SERVICE CHANGES

1. Change on Anvil.

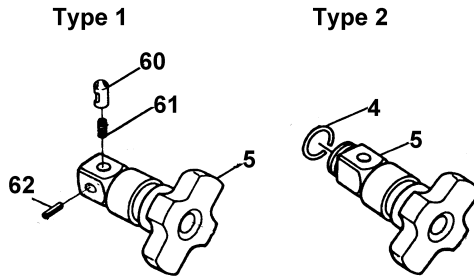
Item No.	Description	Type 1	Type 2
4	Ring Spring 22	-----	231921-7 (Added)
5	Anvil	325414-5 (No Longer Available)	325587-4
60	Pin	325365-2 (No Longer Available)	(Discontinued)
61	Spring	231213-4 (No Longer Available)	(Discontinued)
62	Slotting Pin	256710-9 (No Longer Available)	(Discontinued)

Above parts are completely interchangeable as a set.

When replacing Type 1 Anvil, replace it with complete set of Type 2 parts.
